## **SUPPLEMENTAL INFORMATION**

### **To RFQ UNDP/Projects/197/2017**

**for the supply and delivery of boiler plant (boiler unit and auxiliary equipment) and performance of associated services (installation supervision, start-up and adjustment works, commissioning and training)**

-Item 5.11.1 under "Description / Specifications of Goods (required)" of Annex 1:

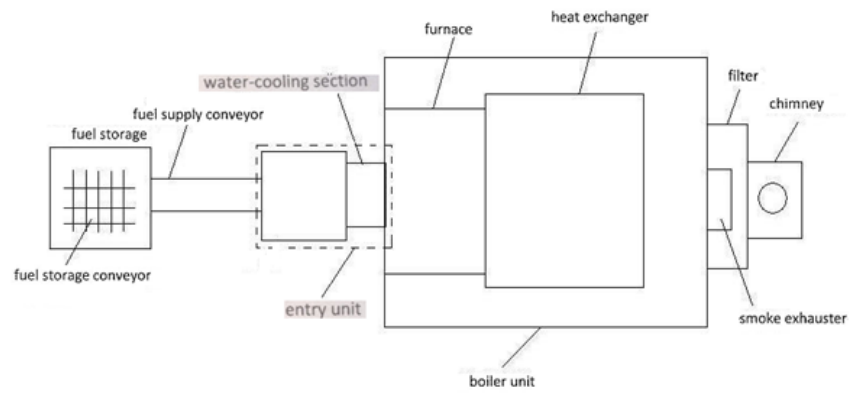
**"Conformity with the requirements of the Technical Regulations of the Customs Union: Copy of the documentary proof (certificate of conformity) of conformity with the requirements of Technical Regulations of the Customs Union or obligation (in an arbitrary form) to provide such document before issuance of the Purchase Order (in the case of award of contract)".**
